Land Use Committee Report

#27-20 Petition to allow Mixed Use Transit Oriented Development at Riverside Station

Riverside Station

RIVERSIDE STATION DEVELOPMENT

Grove Street Design:

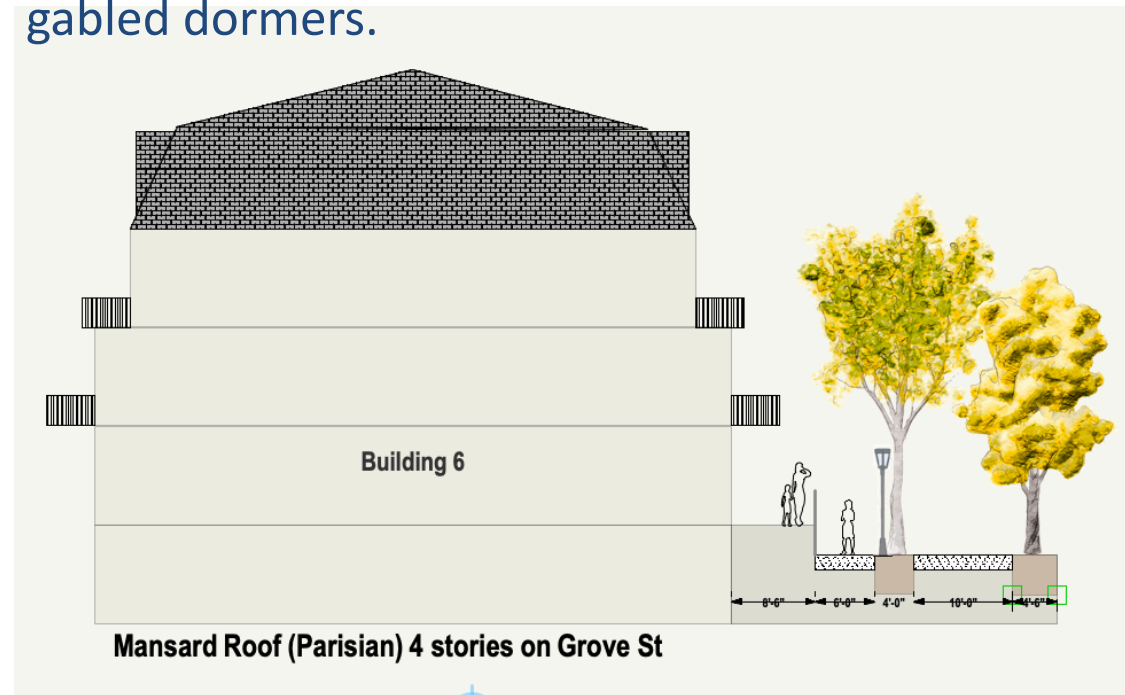
- Plantings and trees in setbacks, setbacks if possible
- Buildings with historic character – e.g., mansard roofs, old mills, Boston's South End
- Brick and/or stone, not vinyl clad
- Arched window heads
- Balconies
- Facade broken up to avoid 200 feet of monotony, yet with a consistent theme
- Buildings 5 and 6 – primary façade needed

Officer Tower Design

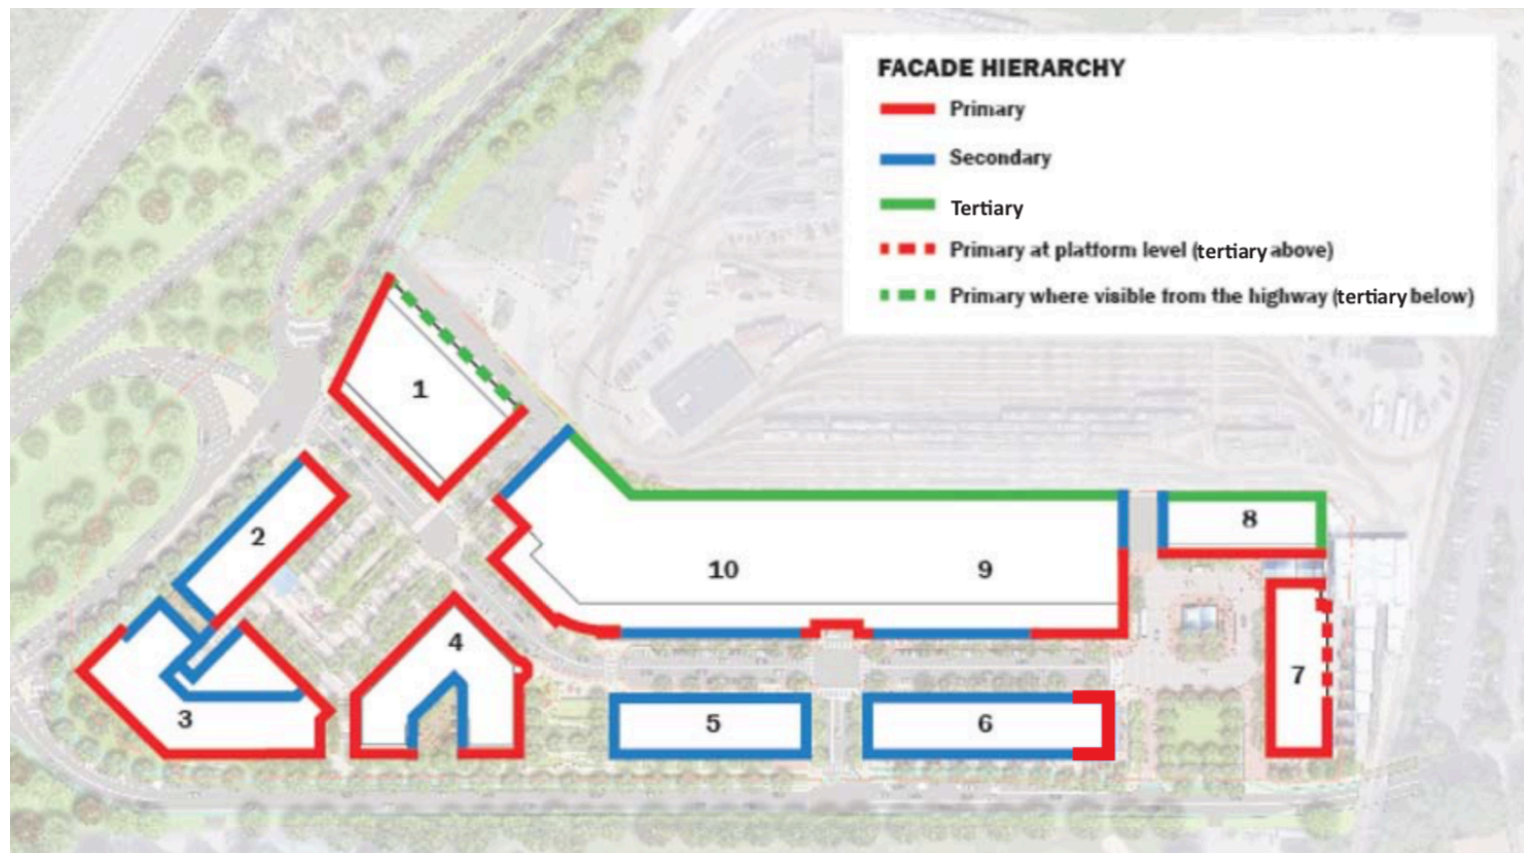
Least preferred

Better
